NOTICE OF
ADDENDUM NO. 1

PROJECT NAME: Low Lift Pump Station (LLPS) Direct Connection and Pressure Regulating Station (PRS) at East Water Purification Plant (EWPP)

PROJECT NO: S-000902-0133-4

ADDENDUM NO. 1

SITE PLAN (1 OF 3)
CWA B - FCV,
COH B - FCV 1,
CONTROL BUILDING (CB-1)

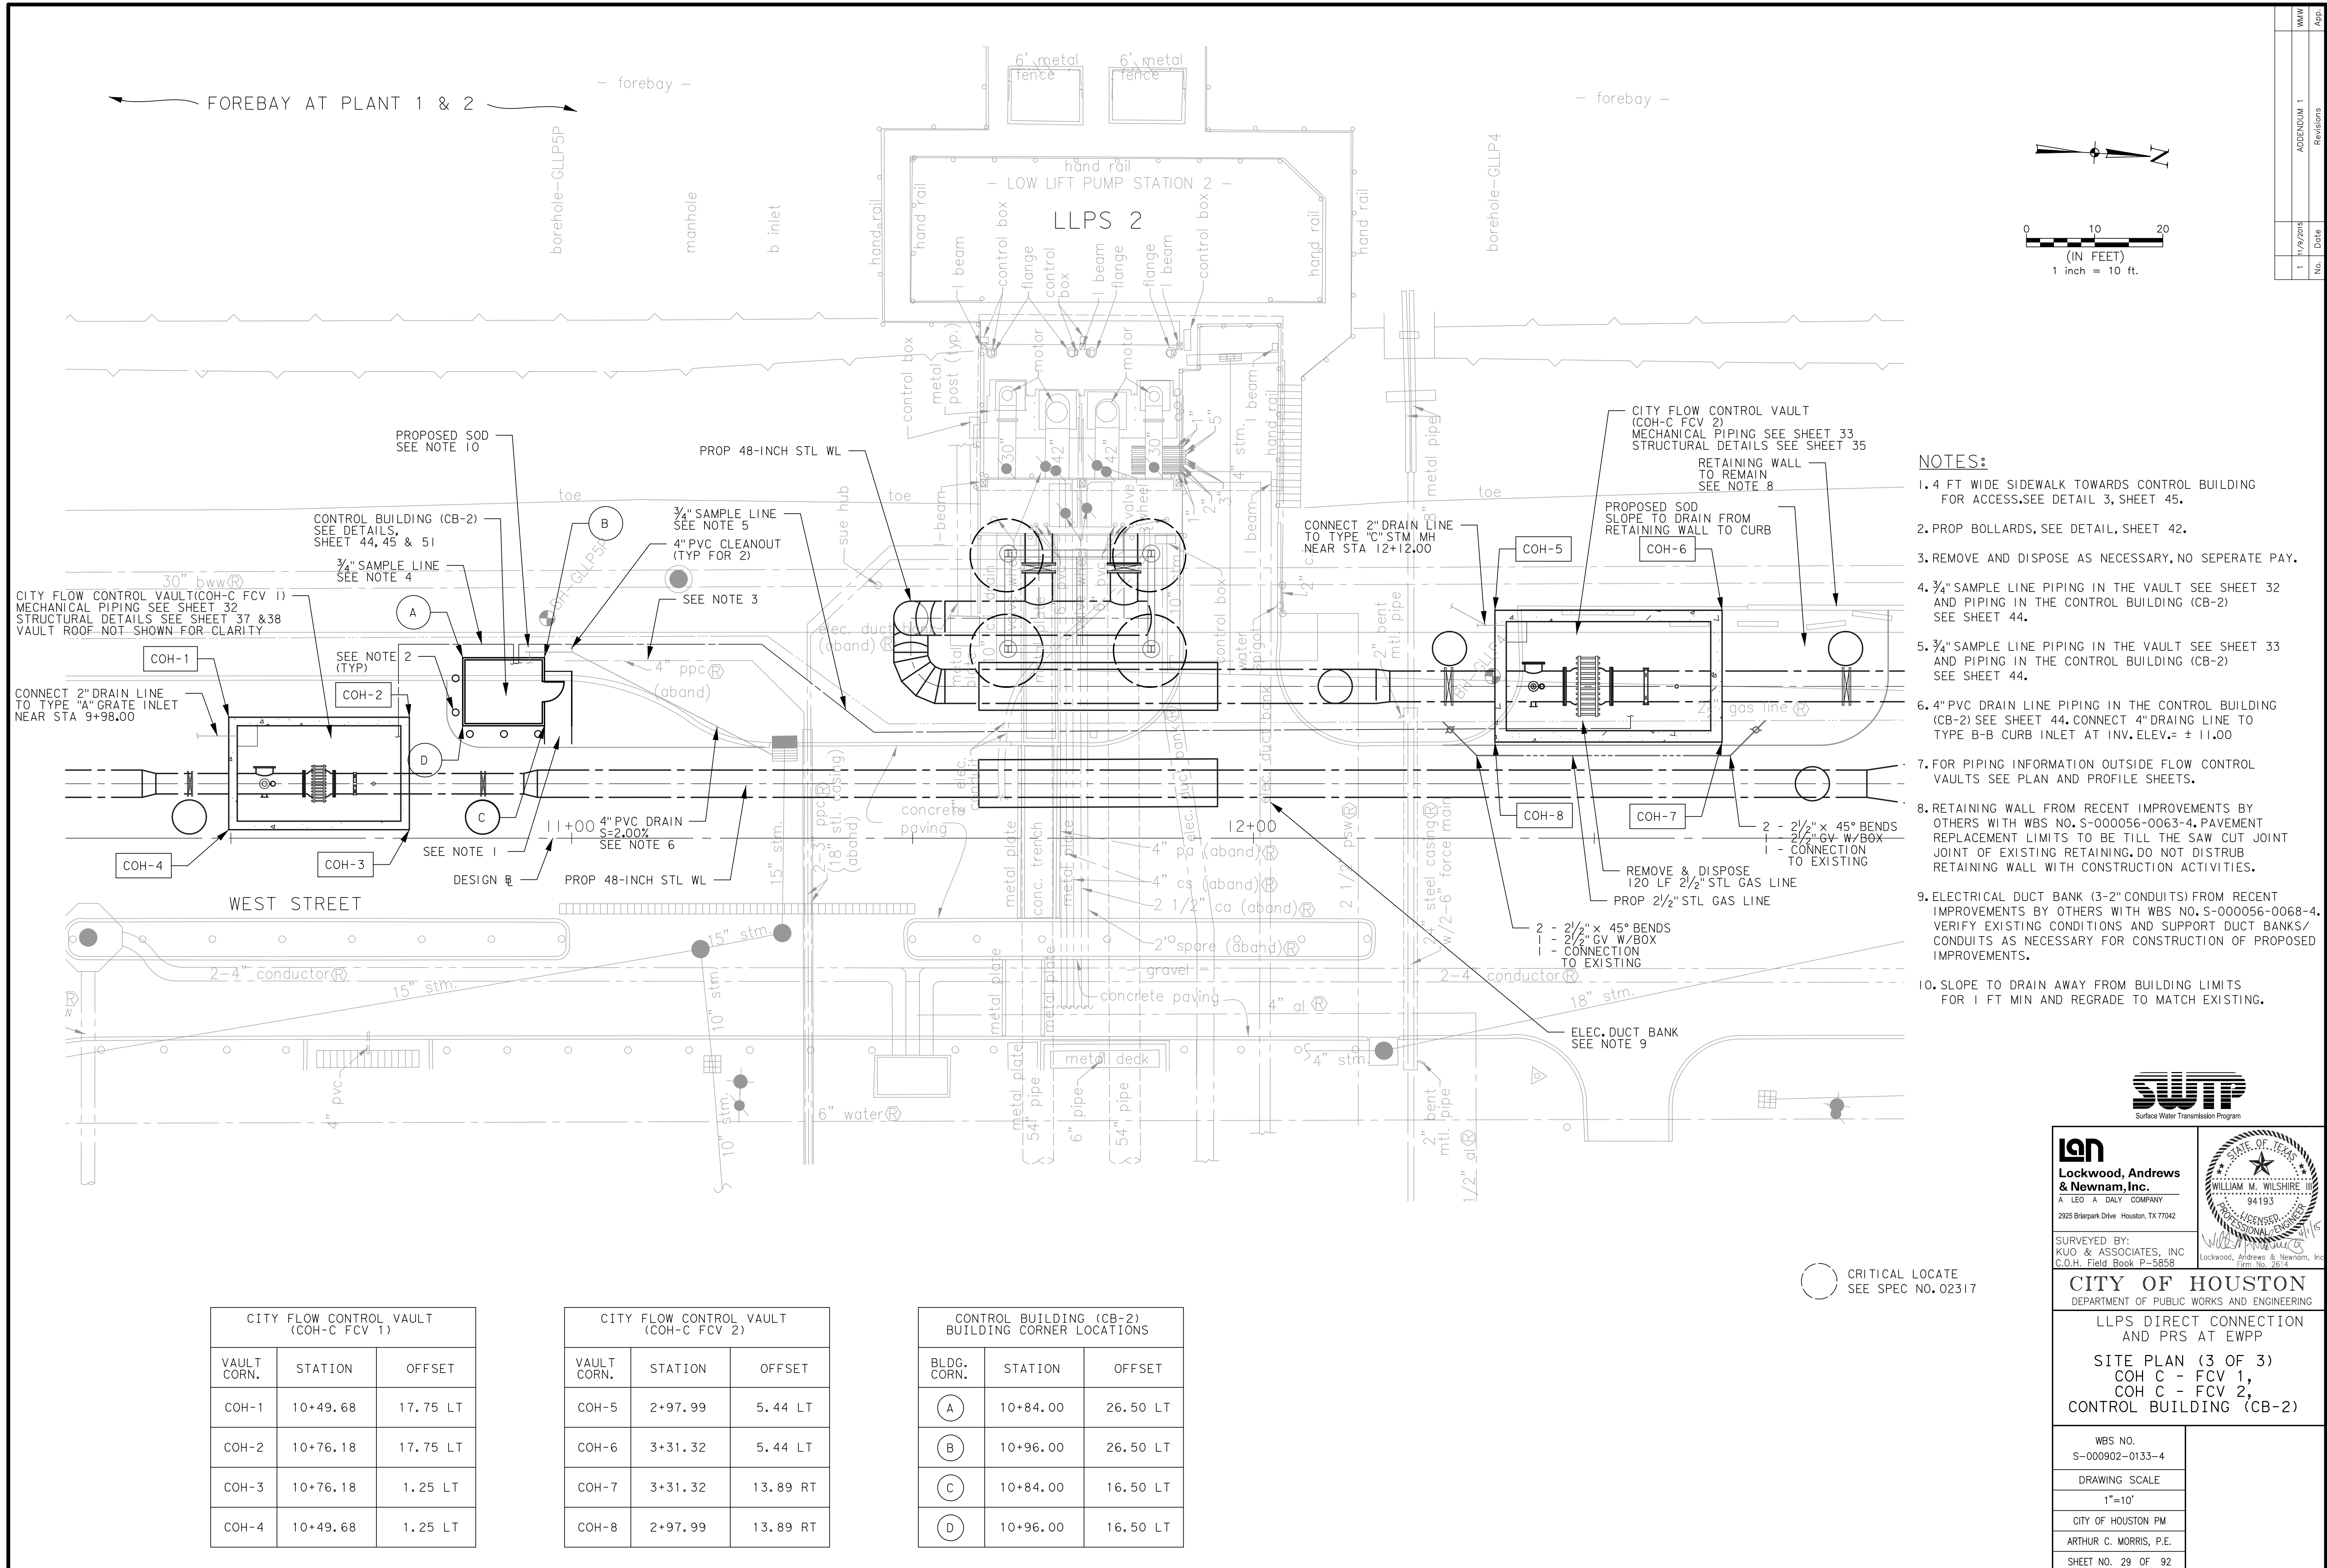
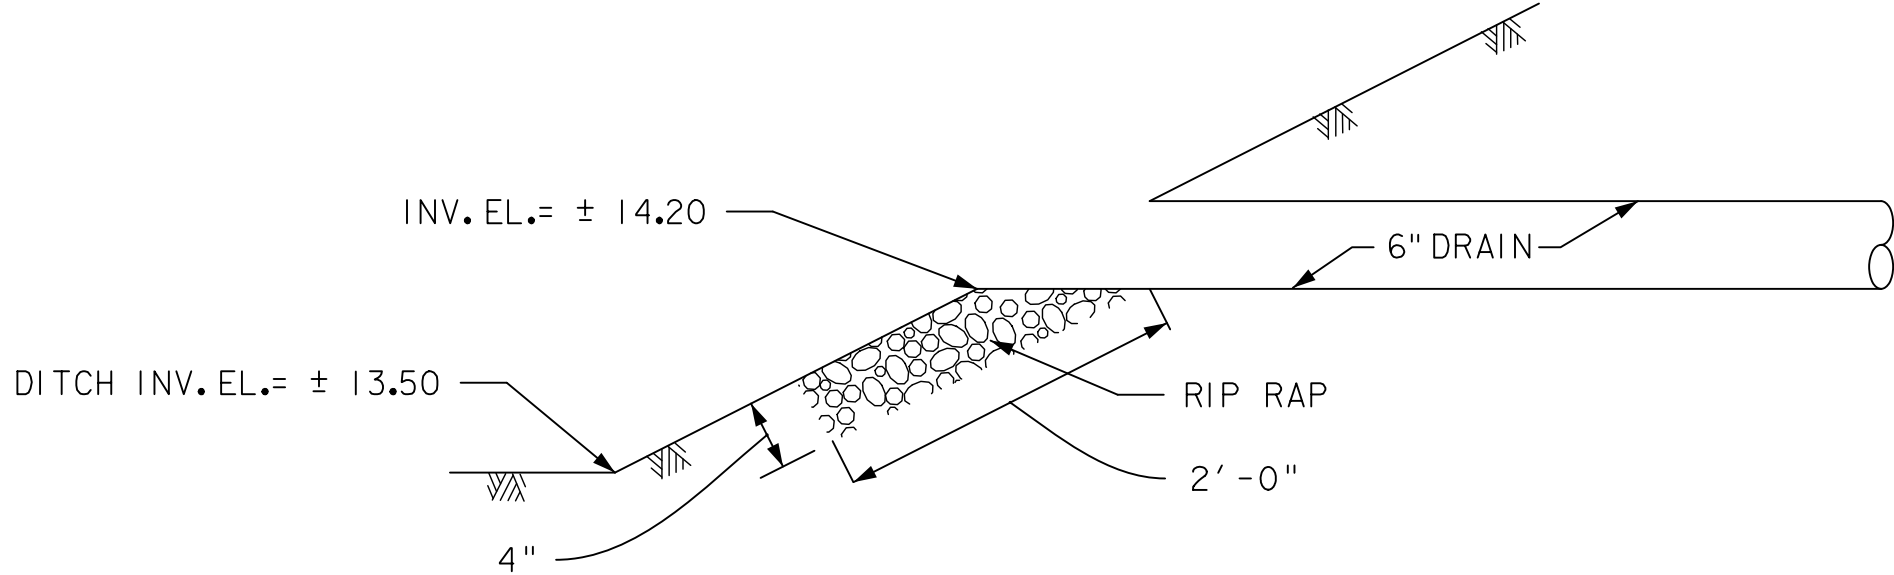
5. REMOVE AND SALVAGE EXIST. WIRE WALL SECURITY FENCE GATE. REINSTALL MODIFIED FENCE GATE AT NEW LOCATION SHOWN ON THE DRAWING. SEE SHEET 28 FOR MORE DETAILS.

16. Drawing Sheet 28. Replace entire drawing sheet with attached Drawing Sheet 28.
